AMENDMENTS TO THE DRAWINGS:

REMARKS

ANNOTATED MARKED-UP DRAWINGS

Fig.1

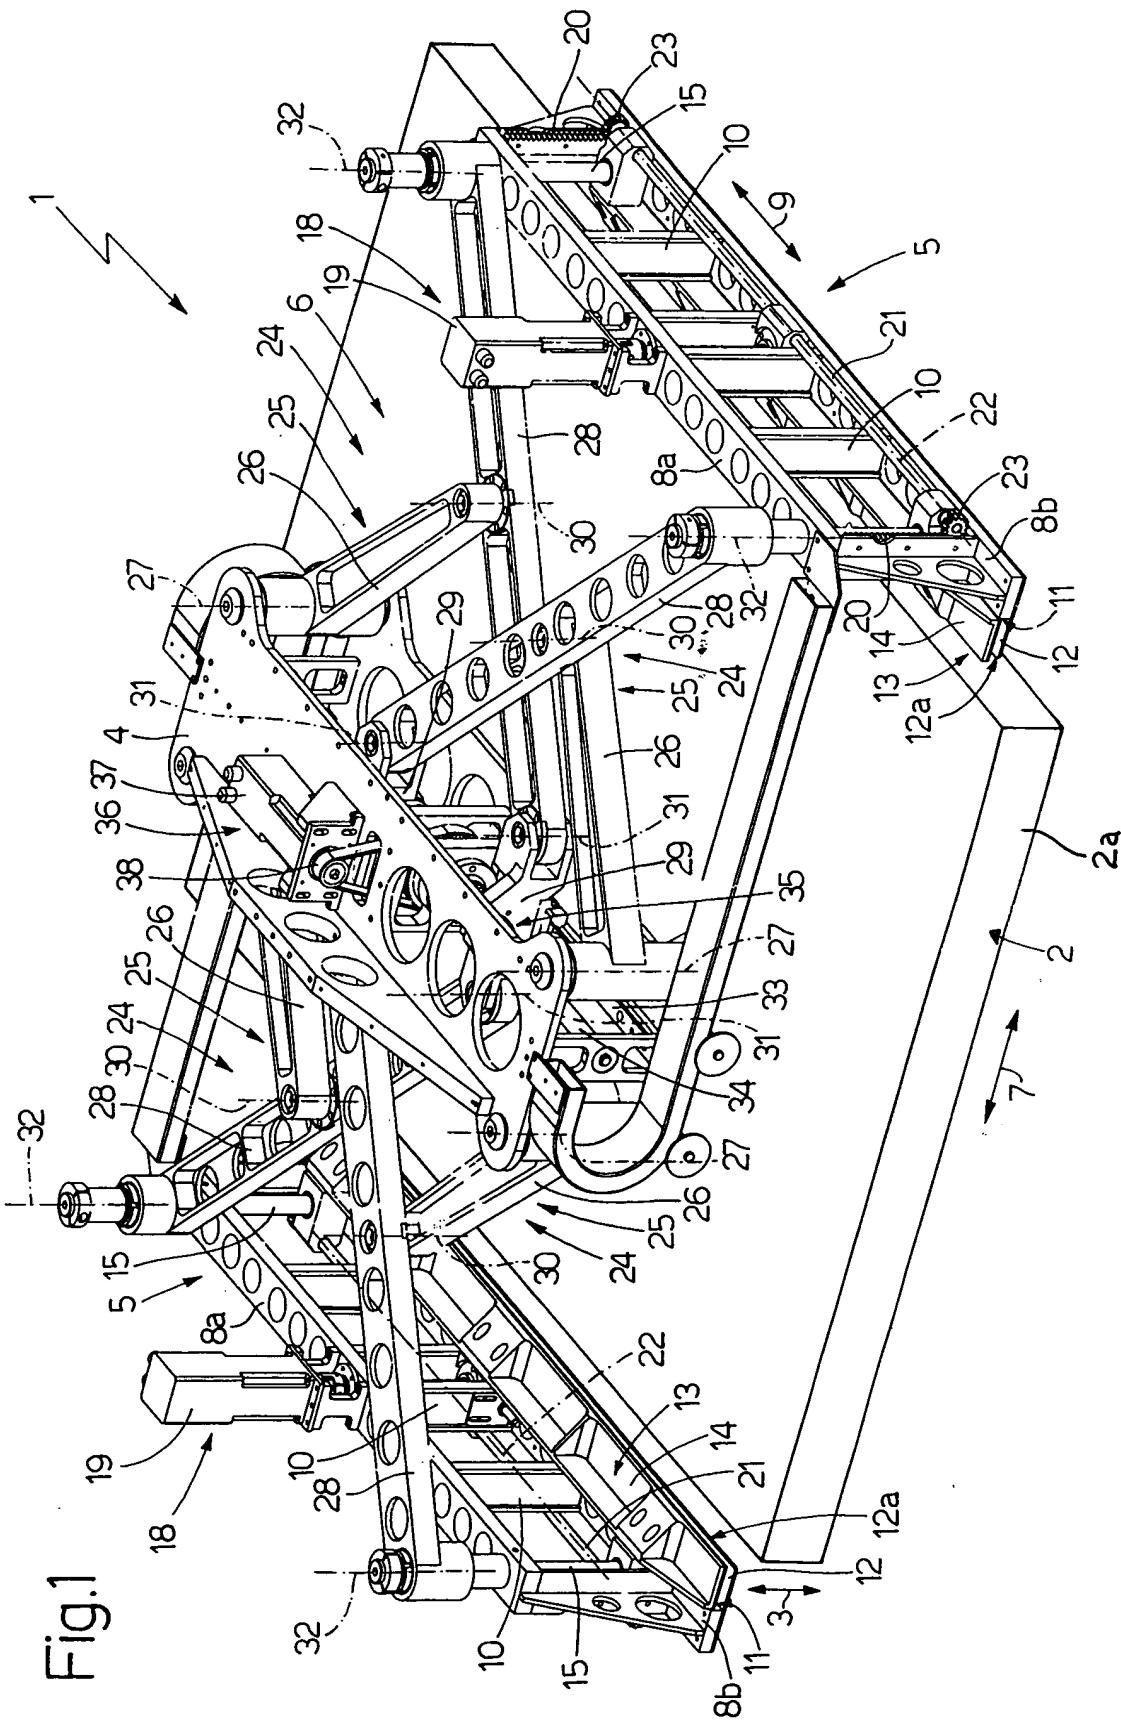
The drawings stand objected under 37 CFR §1.83 as failing to show a jaw moveable parallel to said top and bottom faces (claim 21) and suction means (claim 22).

The drawings also stand objected under 37 CFR §1.84 (s)(p) as failing to contain all numerals in the description and for containing numerals not in the description. Applicants have amended Figs. 1 and 2 to bring the figures into accordance with the reference numerals recited in the specification. Accordingly, Applicants respectfully request withdrawal of this rejection.

Figs. 1 and 2 have been amended to correct reference numerals and add reference numerals mistakenly left off the figures. Annotated marked-up copies of Figs. 1 and 2 are attached and show changes in red. Clean copies of Figs. 1 and 2 are also attached and incorporate the changes.
